LiDAR Quality Assessment Report

KS_HarveyCo_2010-11

This county is part of a 4 county USGS agreement with Kansas (Harvey, Lyon, Morris and Chase Co.). 11 more counties were delivered with the lot as donated data. Three reports will be delivered for the 15 counties - One for Harvey Co. (lot 1), 1 for Lyon, Morris and Chase Cos. (lot 2) and 1 for the remaining 11 counties (lot 3).

Lot 1 of 3 lots.

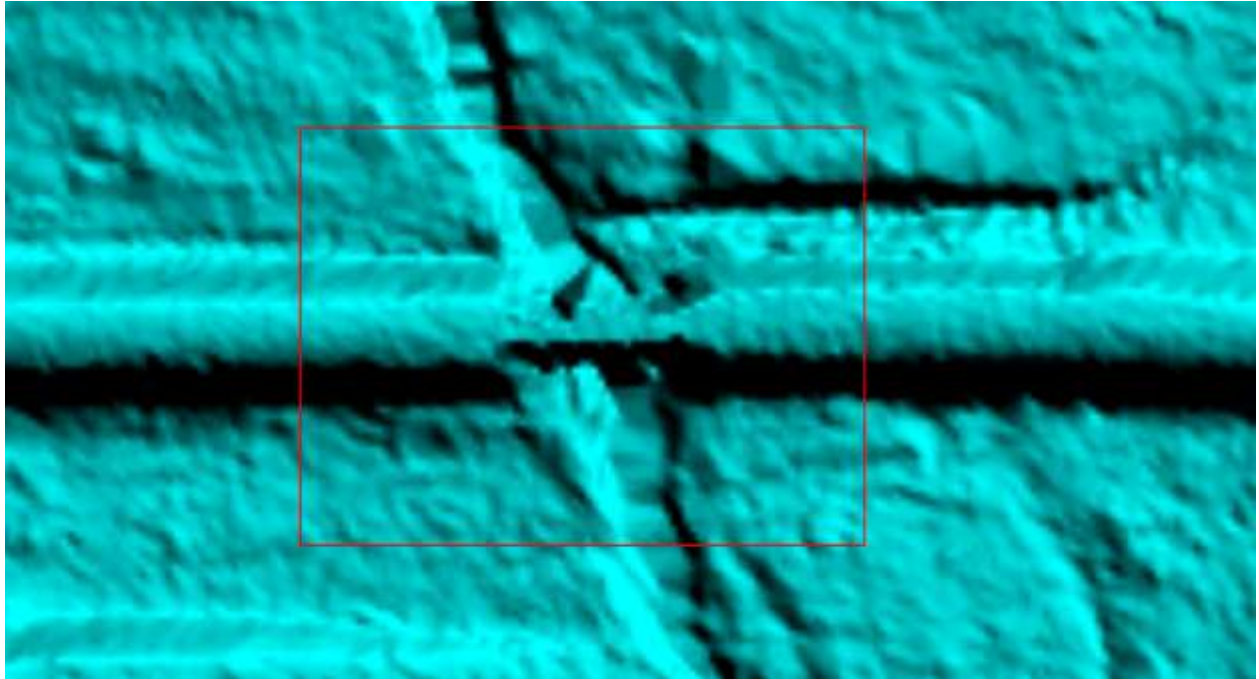
Incomplete bridge removal. This is a representative example of bridge removal errors. Location at 38° 11' 44.6784" N, 97° 30' 53.7711" W

All bridge removal errors were corrected by the vendor

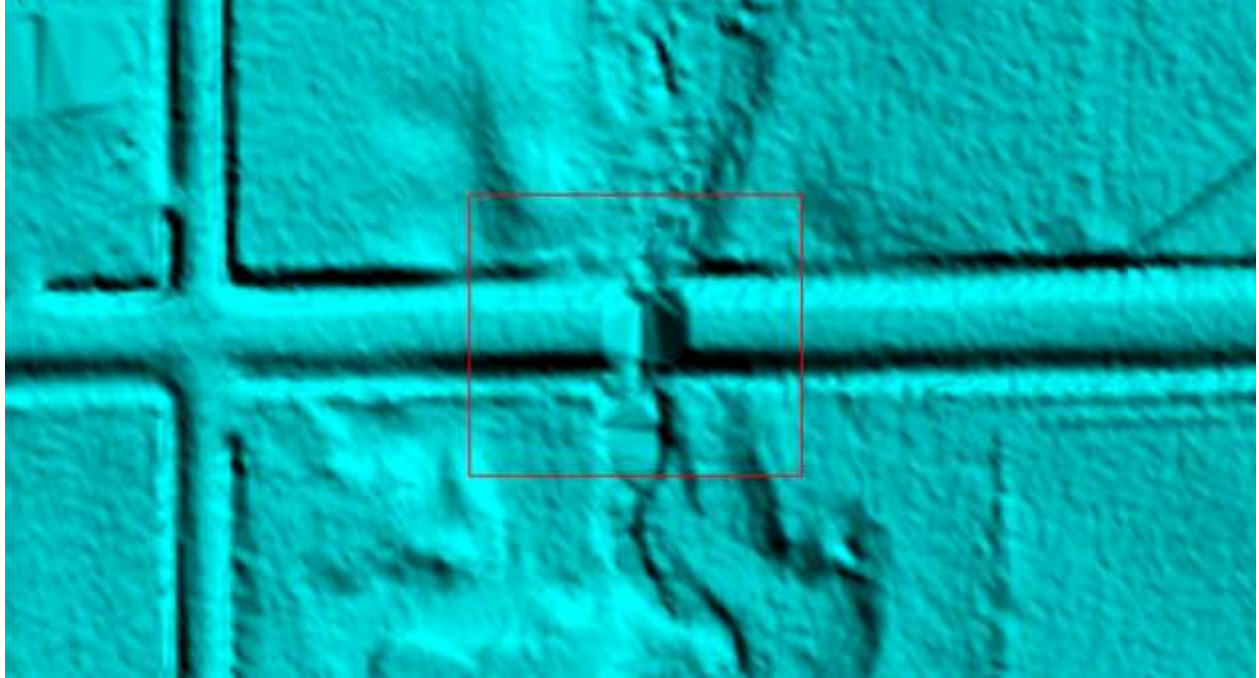
Error in which culvert was removed. This is a representative image. Location at 38° 12' 9.9857" N, 97° 24' 26.3025" W

****Vendor corrected the errors****

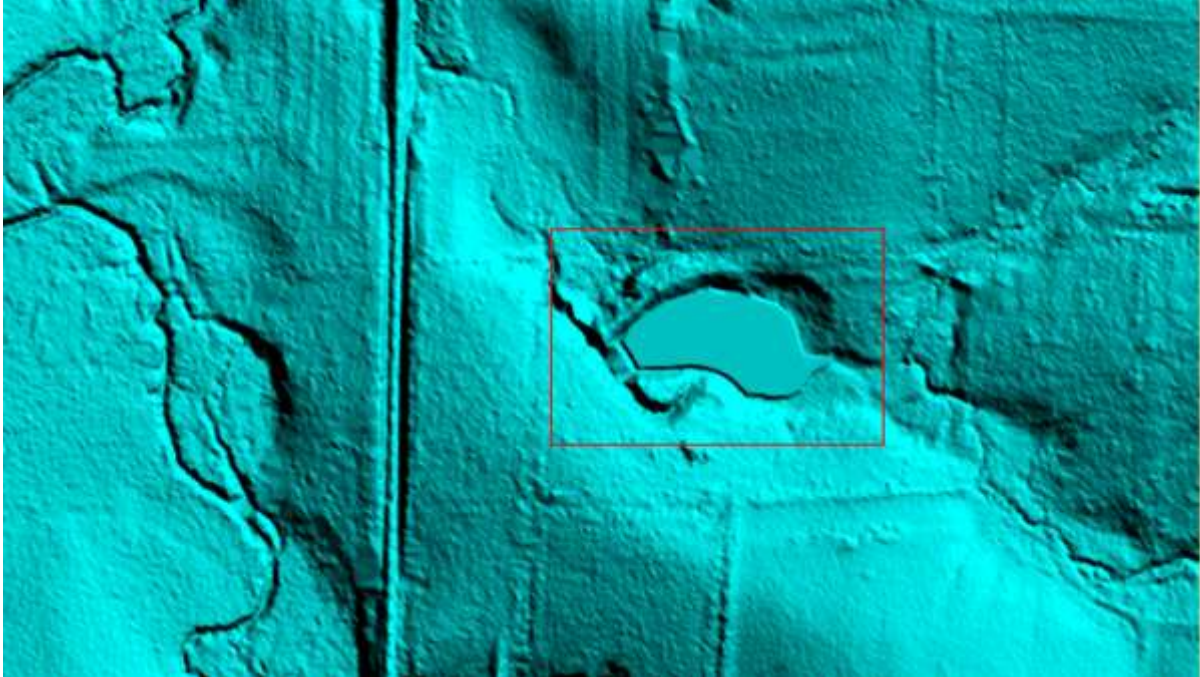
Water is elevated higher than the land surface. This is a representative image. Location at 38° 07' 23.5530" N, 97° 07' 13.4120" W

****All floating water errors were corrected by the vendor****

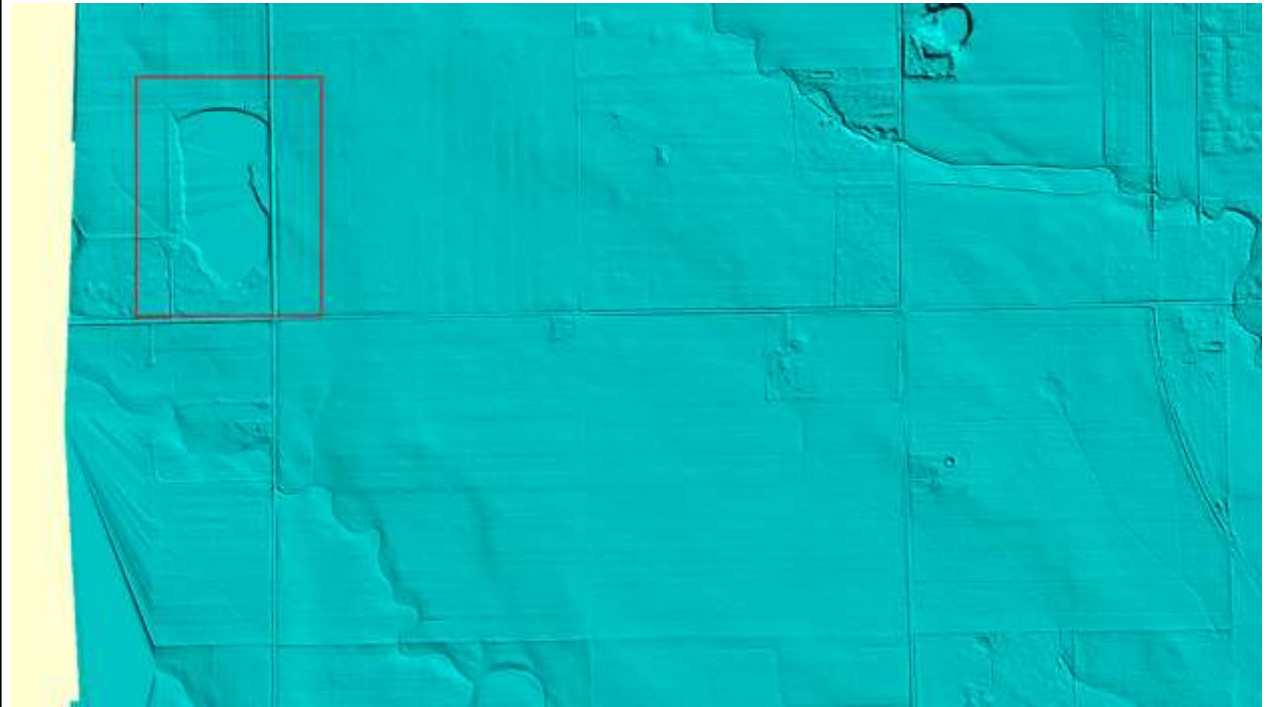
Lake not hydroflattened. There are two errors of this type. Location at 38° 00' 57.7723" N, 97° 42' 9.6131" W

****These two errors still exist in the dataset****

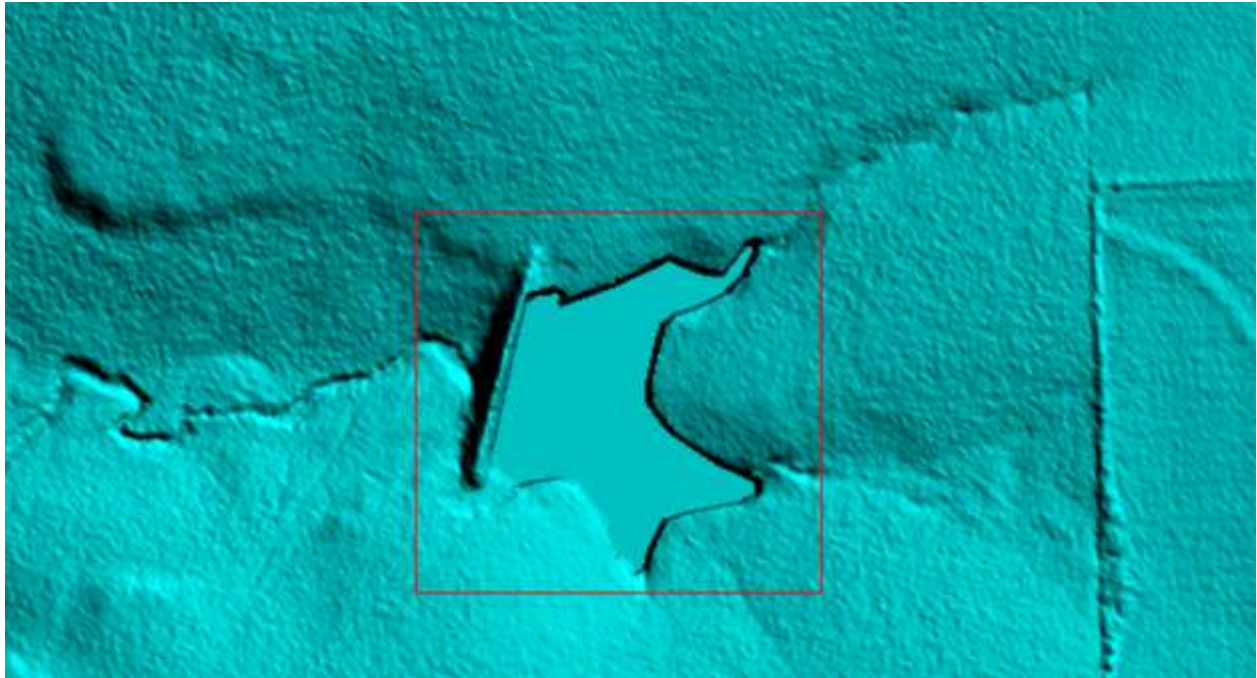
Area of missing data. Location at 38° 03' 13.5158" N, 97° 20' 22.4313" W

****This was corrected by the vendor****

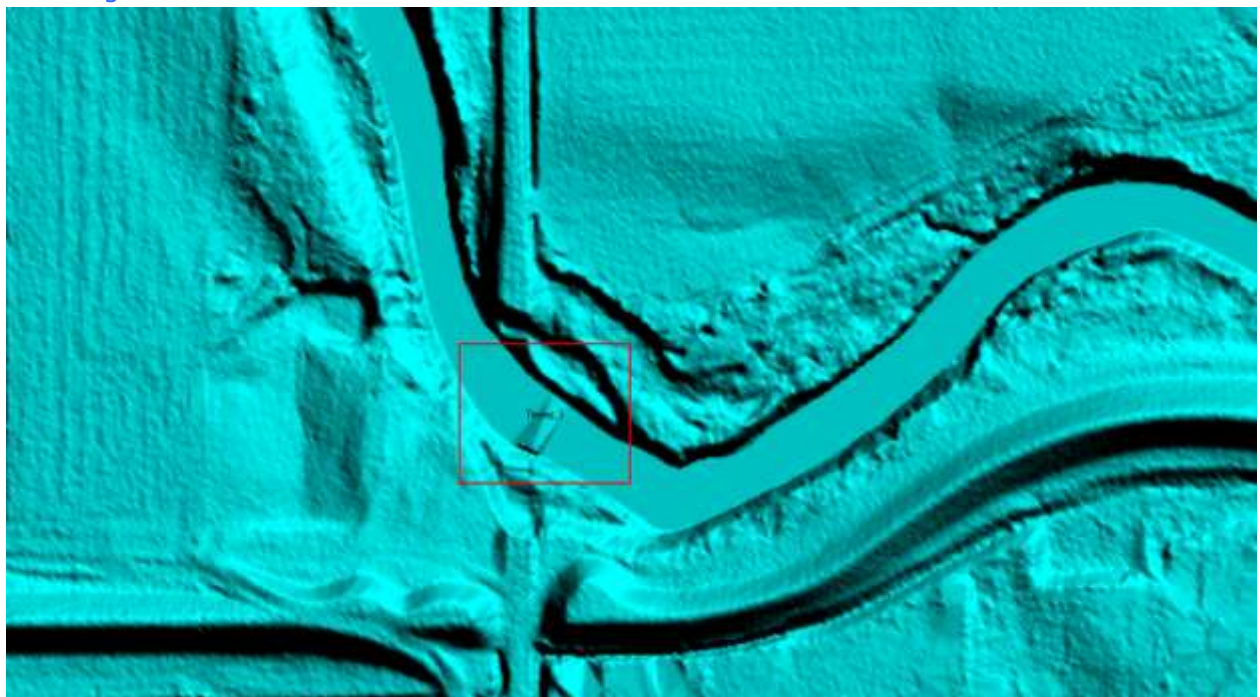
Anomalous feature that stretches across row of data. The area is raised above the land surrounding it and varies around 1-1.5 feet. Location beginning at upper left-hand corner is $38^{\circ} 09' 59.4683''$ N, $97^{\circ} 39' 40.4522''$ W
